PUR-1695 ADDENDUM NO. 1 INVITATION TO BID

ARFF BUILDING DEMOLITION; AOA FENCE/ACCESS GATE REALIGNMENT

DATE: Friday, July 5, 2024 BIDS DUE: Wednesday, July 10, 2024

ES100

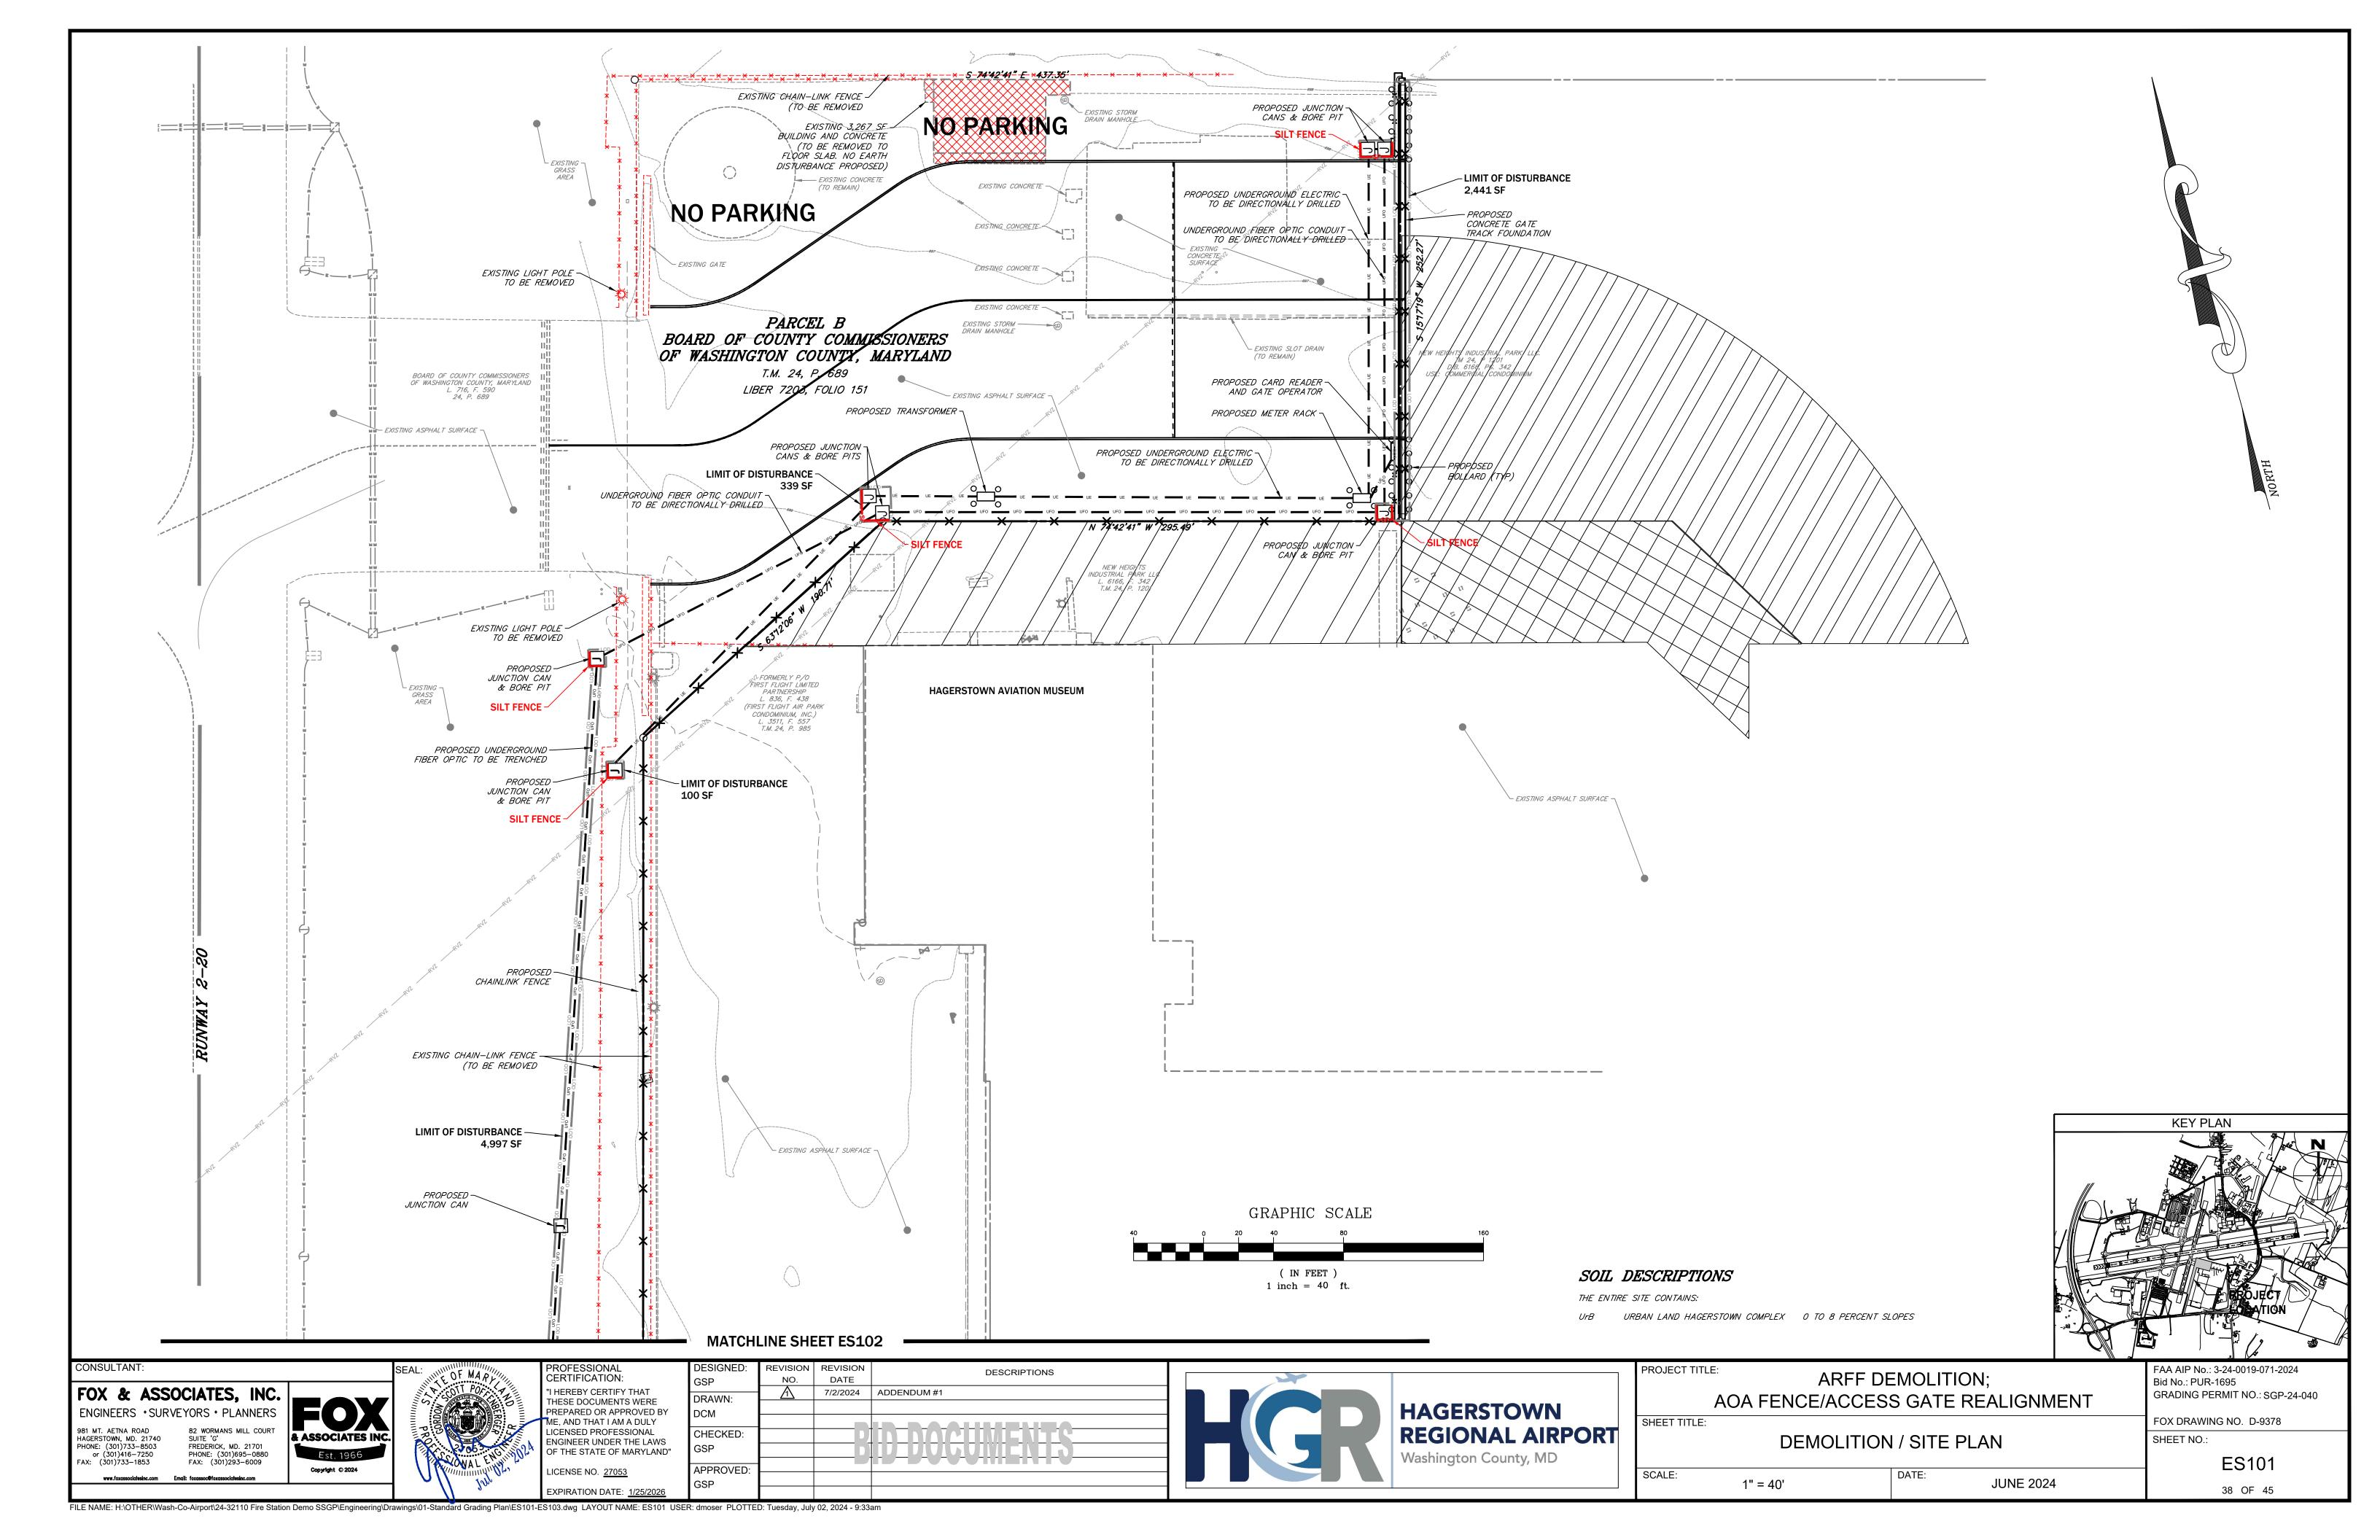
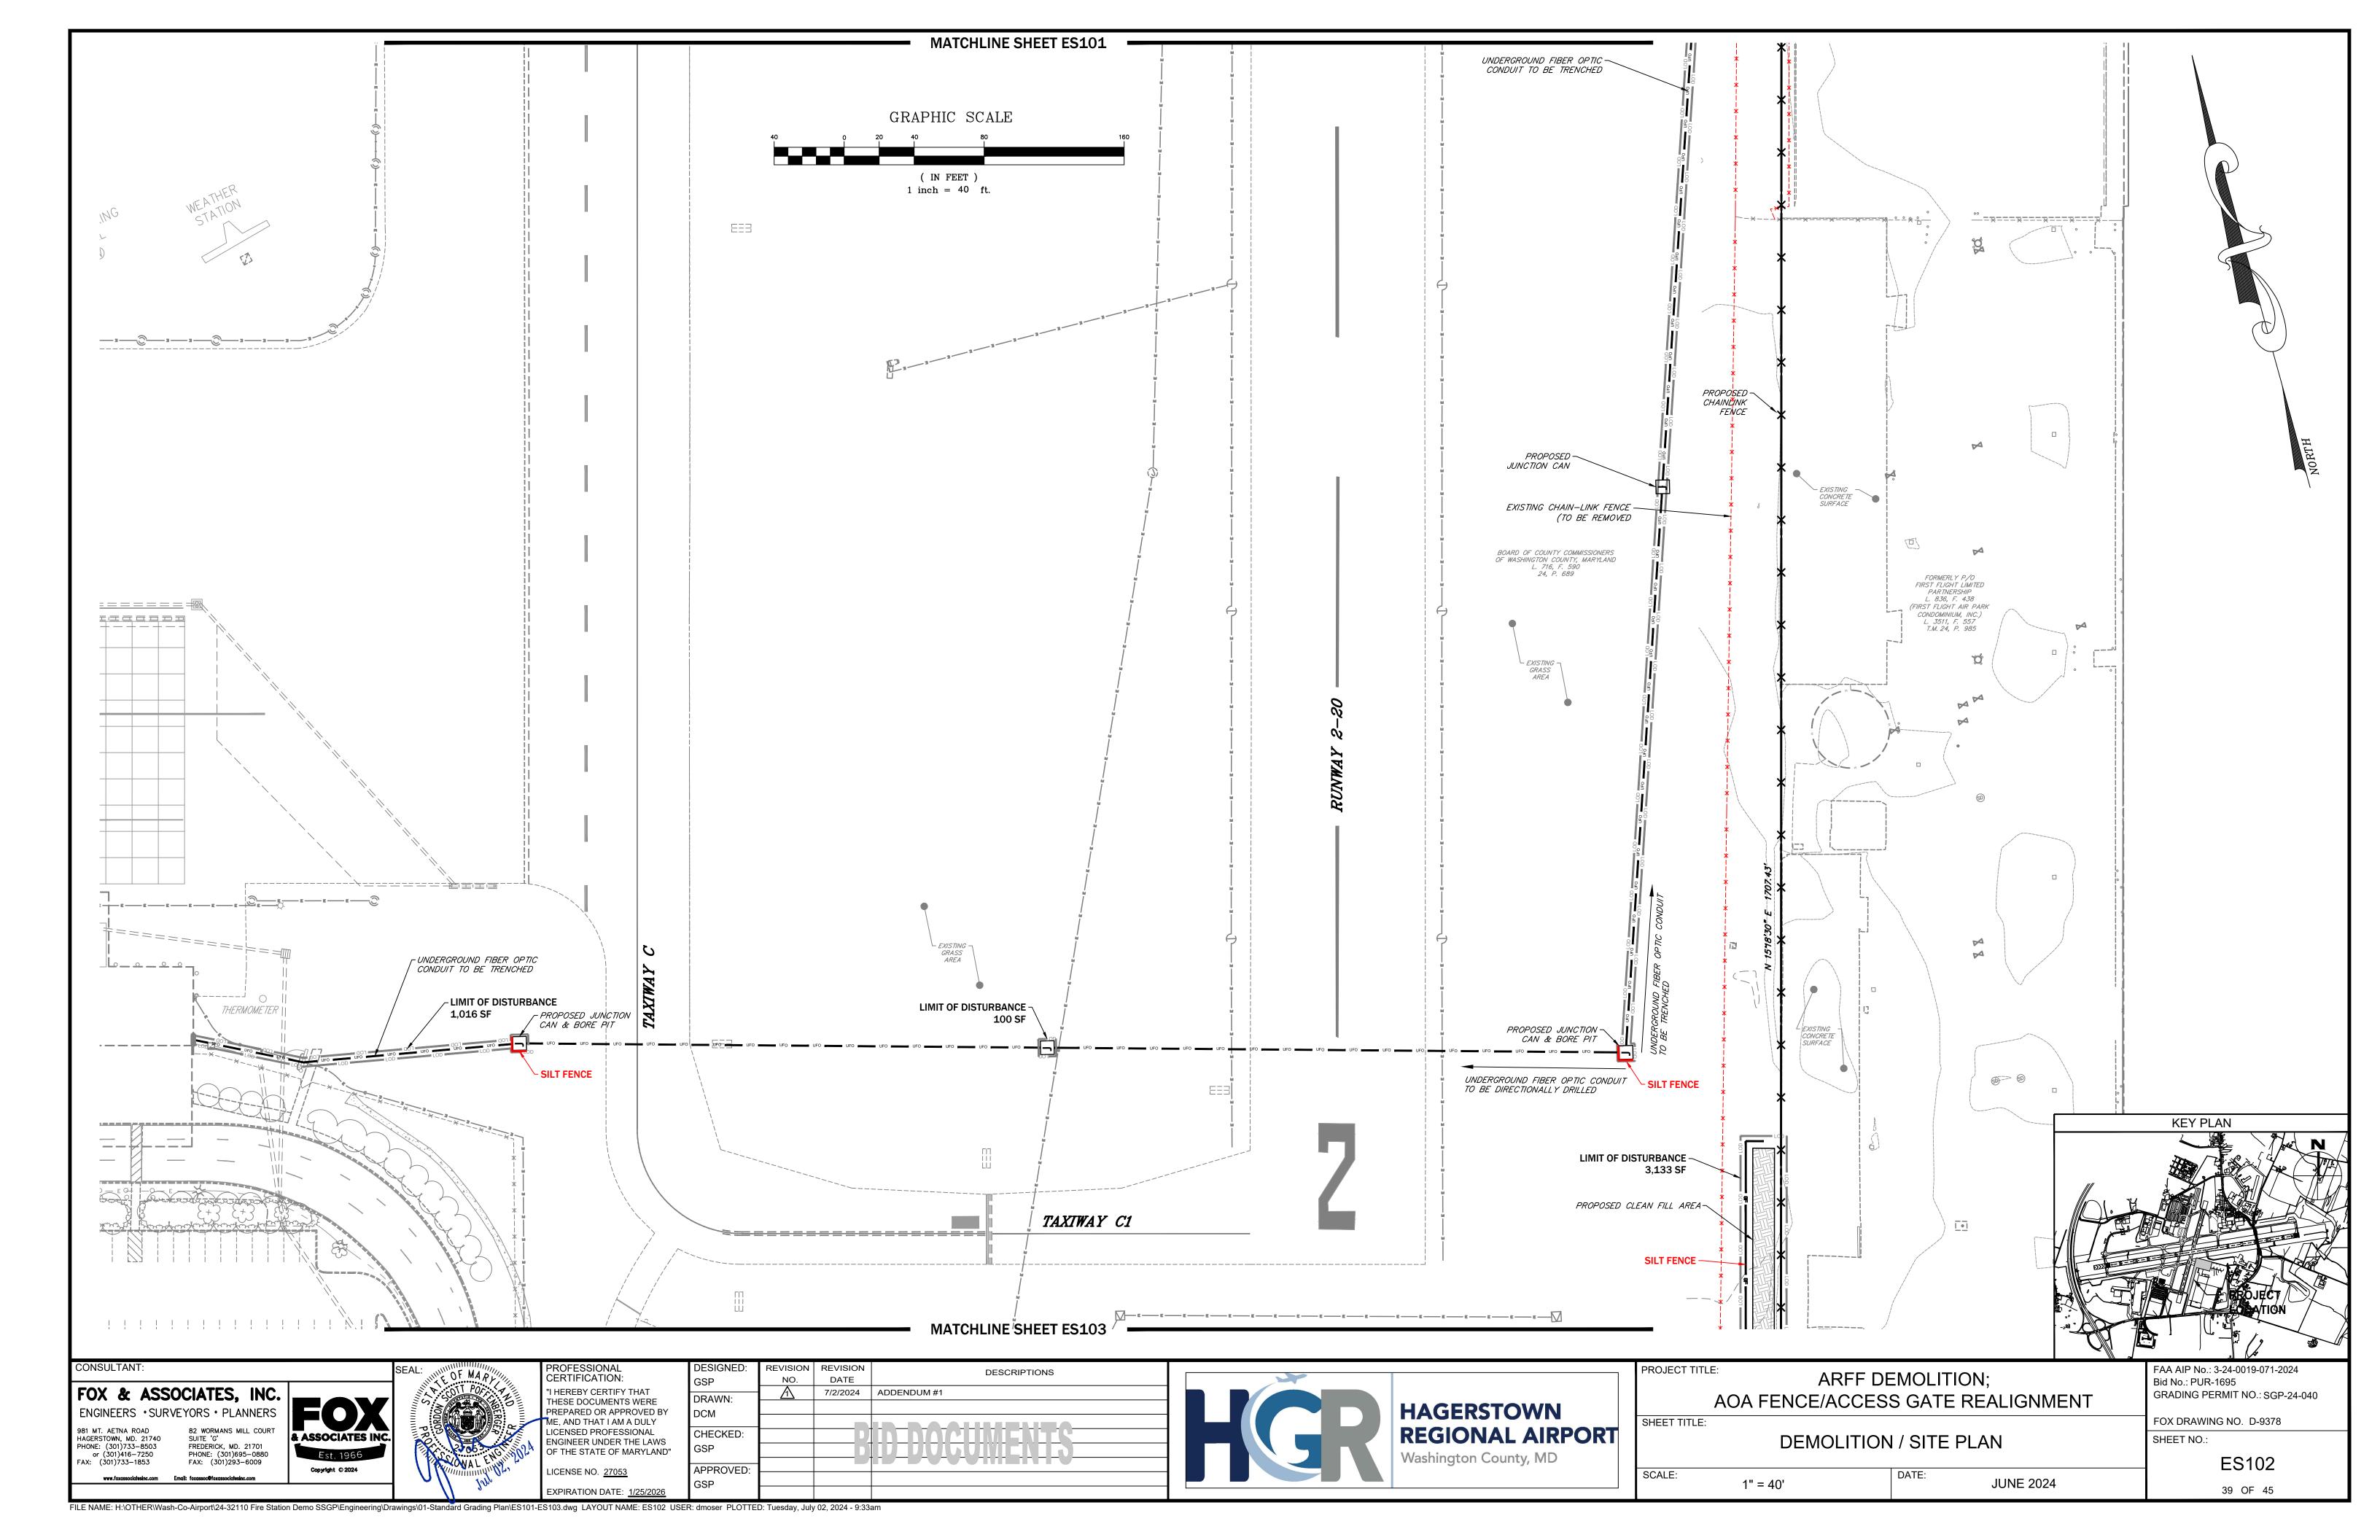
ITEM NO. 4: Inquiry: Do you have existing grading plans or information on existing grades in the area of the new 160' gate? The new gate has a very small tolerance for slope, the concrete foundation / track must be installed with a maximum slope of 1.5" per every 10' of track. It is our understanding that the existing asphalt in the area of the new gate location contains slopes greater than this allowance. This could require significant changes to existing grades and significant amounts of new paving to prevent to provide gradual transitions between existing pavement and the proposed gate track.

<u>Response</u>: We have included the site-specific grading plans that were utilized to obtain the grading permit. Please INSERT Sheets 37-41 which are provided by Fox & Associates, Inc. There will not be significant changes of grades needed in the proposed area of the 160' gate opening, however, there may be some minor transitional milling and/or paving required to tie portions of the proposed concrete gate foundation and existing grades together. This was called out on Note 5. of Sheet CF202 and is incidental to the installation of the gate.
